**DSP-11017
 SP-110002**

STAFF REPORT

SUBJECT: Detailed Site Plan DSP-11017
Special Permit SP-110002
Hyattsville Subway Sandwich Shop

SITE PLAN

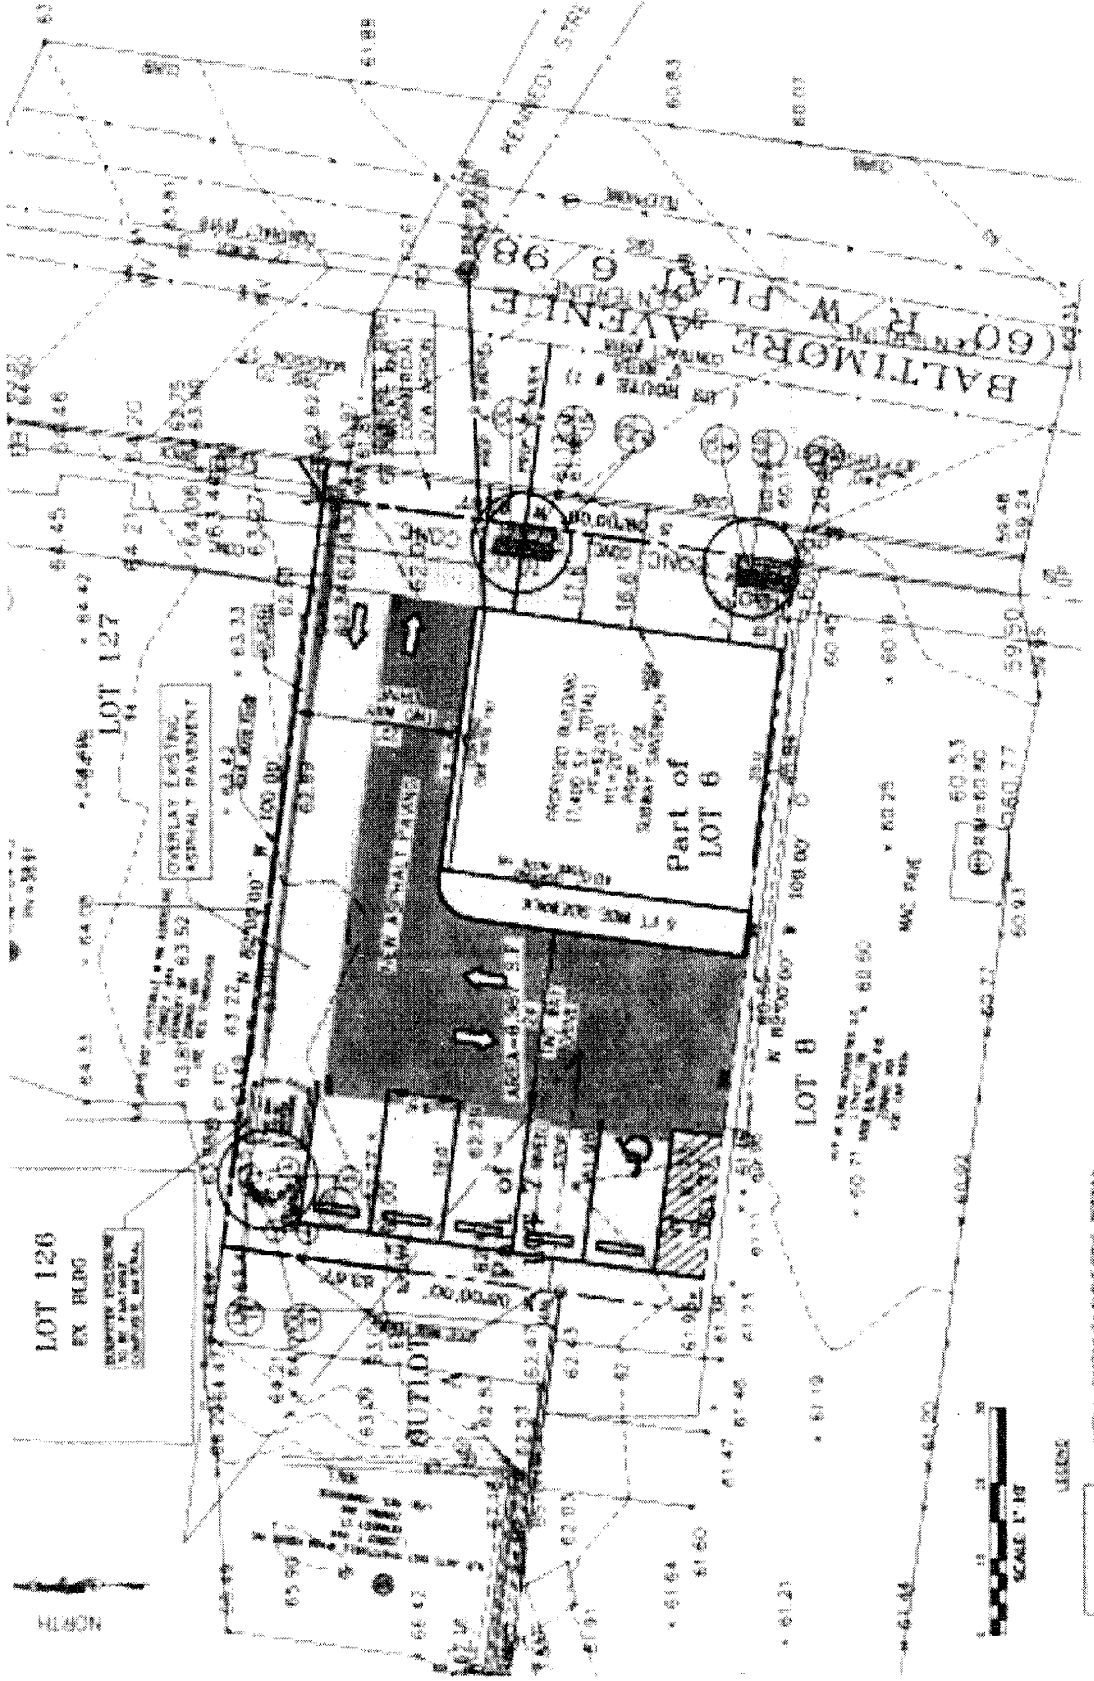
The applicant is showing the adjacent concrete sidewalk being continued across the access drive. By condition below, the brick on the adjacent property within the state right-of-way should be shown across the frontage of the subject project unless modified by the Maryland State Highway Administration (SHA), and the landscaping should be revisited so as to make the streetscape on both the subject and adjacent properties continuous, with final design to be approved by the Urban Design Section as designee of the Planning Board. All tree boxes in such redesign shall meet the minimum requirement of ten feet by five feet.

Comment: The detailed site plan, but not the landscape plan, indicates two semicircular light fixtures in plan view. No detail for the fixtures is provided. The only additional information regarding lighting is provided in Note 19 which states: “Adequate lighting shall be provided that will not cross over to neighboring property and to minimize overall sky glow.” This is insufficient to evaluate conformance to this development district standard. Additionally, there are no lights indicated on the front of the building or at the rear of the site. Staff has included a proposed condition of approval that would require, prior to signature approval, the applicant to revise the detailed site and landscape plans to include a detail and additional lighting that would address the front of the building and the rear of the lot. Further, in order to ensure that off-site light intrusion into adjacent and environmentally-sensitive areas designated by the 2005 *Approved Countywide Green Infrastructure Plan* is minimized, and so that sky glow does not increase as a result of this development, the detail provided shall reflect a full cut-off optical fixture.

Comment: As the tree boxes shown do not meet this minimum requirement and because the streetscape is recommended to be redesigned prior to signature approval, staff will ensure that, in the redesign of the streetscape, the tree boxes meet this minimum requirement.

The site plan shows a dumpster enclosure. An elevation of the enclosure and the materials used should be noted on the plans to ensure the standard is being adhered to.

The tree boxes shown on the landscape plan are not detailed. It appears the dimensions on the plan show 4 feet by 8 feet. Either the tree boxes will need to meet the standard or an amendment to the standard must be requested. It appears there is adequate room on the sidewalk to accommodate a larger tree box.

1. Prior to signature approval of this detailed site plan, the following revisions shall be made to the plans and additional specified documentation submitted:
 - a. Add the deed reference “Liber 32700 at Folio 237” to the plan notes.
 - b. Add the underlying property information to the plan drawing.
 - c. Add the material label of “stucco” to the yellow-colored portions of the front façade elevation drawing, if it is to remain an architectural material for the project.
 - d. Revise the parking schedule as follows:
 - (1) To reflect that the total number of parking spaces required is 8 (1 per 3 seats) for the 18 seats provided, and two for the 80 square feet of gross floor area (excluding any area used exclusively for storage or patron seating, and any exterior patron service area).
 - (2) To remove the following incorrect statement from the parking schedule (General Notes, Sheet 2):

“Parking required is reduced by 50 percent based on Gateway Arts District requirements.”
 - e. The proposed outdoor lighting shall be evaluated for full cut-off optics fixtures to ensure that off-site light intrusion into adjacent and environmentally-sensitive areas designated by the 2005 *Approved Countywide Green Infrastructure Plan* is minimized, and so that sky glow does not increase as a result of this development.
 - f. A minimum of five bicycle parking spaces shall be provided at a location convenient to the building entrance. The location and number of spaces (bicycle racks) shall be approved by the Urban Design Section and trails coordinator.

- j. The handicapped parking space shall be dimensioned as 16 feet by 19 feet.
- k. The dumpster detail shall be revised to indicate face brick to match the color of the brick to be utilized on the first story of the building as the external sheathing architectural material.

- l. General Note 4 on the detailed site plan shall be corrected to indicate that the proposed building height is 20 feet, 1 inch as indicated within the building footprint and by the submitted building elevations.

- s. The applicant shall revise the architecture for the project as follows:
- (1) Storefront glass shall comprise a minimum of 60 percent of the front façade;
 - (2) Red brick shall be applied to the entire first story of the building, extending as pilasters up to the sign band on the front façade;
 - (3) The stucco “crown” shall be embellished to become a decorative entablature;
 - (4) The internally-lit sign shall be replaced with a wooden painted sign, lit by a gooseneck spotlight.
 - (5) The dumpster enclosure shall be sheathed in red brick and the gates of the enclosure shall be of a green, non-wood, low sheen, durable material. The color shall match that of the canvas awnings of the front façade.
